Old Bassett Residents' Association, c/o 15 Pointout Close, Bassett, Southampton SO16 7LS 30/07/2022

Ref Panel Meeting – 02/08/22 – Agenda Item 22-00399-FUL #59 Burgess Road

Retention of "as built" retaining wall (retrospective).

Extract from PLAN_AND_TOPO_SITE_PLAN_OVERLAY-1675524 . Red = Applicant's version of title deed boundary (not 100% correct). Purple = applicant's lines showing end of retaining wall and single skin block wall. Yellow = our correction showing actual extent and orientation of built development.

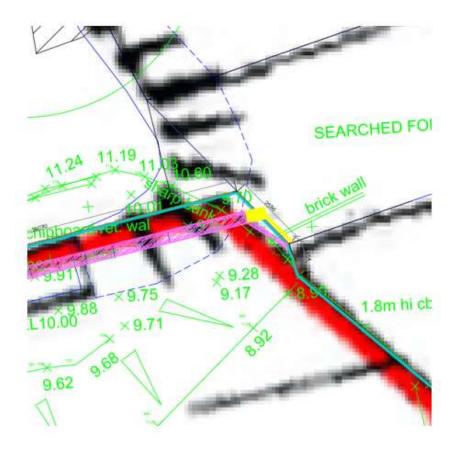
It is a criminal offence to knowingly make a false declaration on a planning application, and the applicant has done that multiple times. The Applicant, in all their previous planning applications has claimed ownership of all land affected by the proposal, contrary to the evidence of their title deeds which was pointed out to them by neighbours multiple times. Council has previously been provided with evidence in the form of text messages from the Applicant to a previous owner of #27 Pointout Close in which the Applicant was trying to purchase the ends of gardens in Pointout Close to gain a rear access route. The applicant knew full well that they didn't own the land but just went ahead with deliberate encroachment at a time when the owner of #27 was in a medically-induced coma with Covid and was powerless to prevent it. Finally a few weeks ago, the applicant submitted a Certificate B, which formally acknowledges that they do not own all the land. A certificate B should be served at least 21 days before an application is submitted, not many months after. It should also be publicised by council which it was not. Council could have dismissed the application at that stage and required a new submission based on correct ownership certificates and correct boundary placement but it did not. Then 3 new plans appeared, one of which overlays an approximation of the true title deed line on the OS data and shows clear encroachment and overbuild onto #27, albeit not as extensive as the actual encroachment.

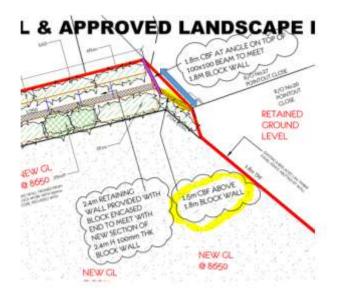
Despite this, the remaining 2 new plans submitted at this time still use OS data to incorrectly define the boundary. They also clearly show the single skin wall in the wrong position and the wrong orientation. The Case Officer report does not mention this. Why?

In above, boundary Line is OS line, not title deed line. Actual position of 1.8m block wall is inset onto #27 and points in direction of blue arrow from end #26 / #27 boundary to end #27 / #28 boundary.
